**PREVOST**ENREGISTRÉ - REGISTERED  
**ISO 9001 & ISO 14001****WARRANTY  
BULLETIN**

Wb07-12

<b>DATE : DECEMBER 2007</b>	<b>SECTION : 05 - Cooling</b>
<b>EXPIRATION: DECEMBER 2009</b>	
<b>SUBJECT : REPLACING THE PIPE CONNECTING THE TURBOCOMPRESSOR TO THE CHARGE AIR COOLER (CAC)</b>

FIGURE 1: ENGINE COMPARTMENT

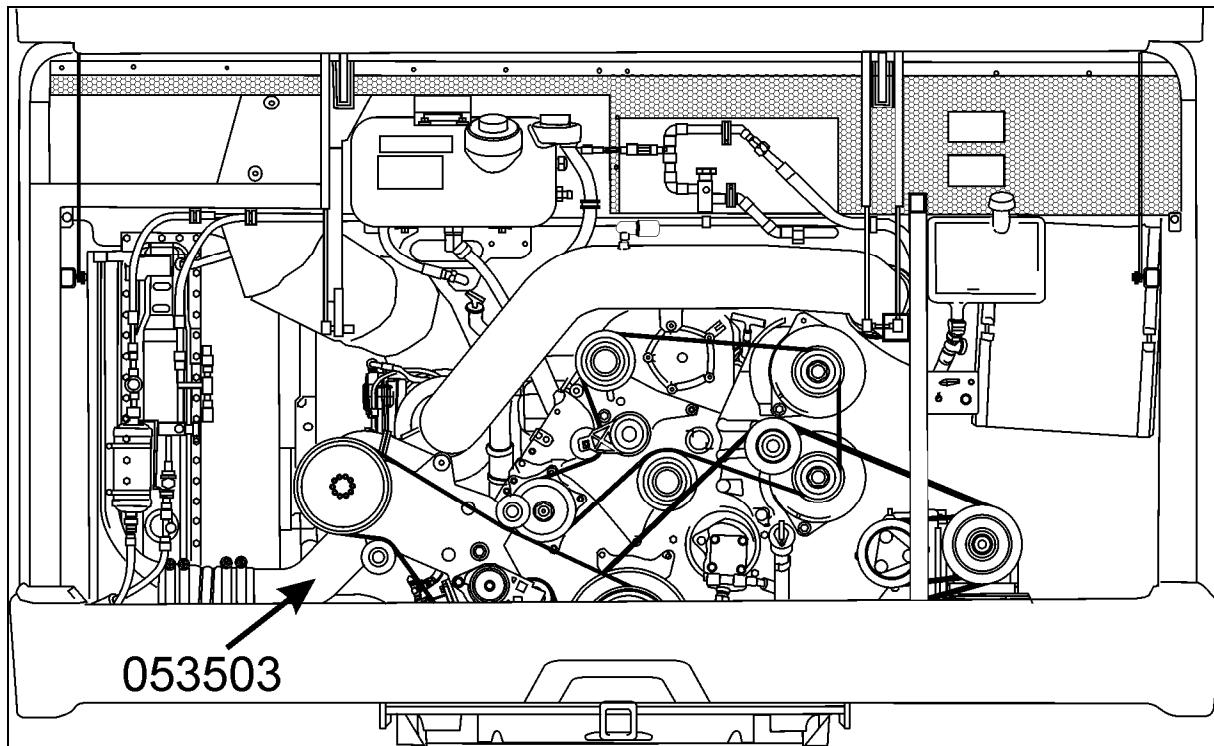
On the above-mentioned vehicle, there is a possibility that the connecting pipe located at the turbocompressor outlet strikes against the radiator fan drive mechanism support. Abrasion or perforation could result and thus result over the long run in damage to the Diesel Particulate Filter (DPF) or loss of engine performance.

1. Open engine compartment door.
2. Set rear start switch to the OFF position.
3. Locate connecting pipe then untighten the constant-torque hose clamps fixing the connecting pipe (Refer to figures 1 and 2).
4. Remove the connecting pipe and install the new one (053503).
5. Torque hose clamps to 9-11 lbf·ft (Refer to figure 2).
6. Position the CAC pipe, coolant line and cooling fan drive mechanism universal shaft so that the various gaps are respected and that no rubbing occurs between the various parts.
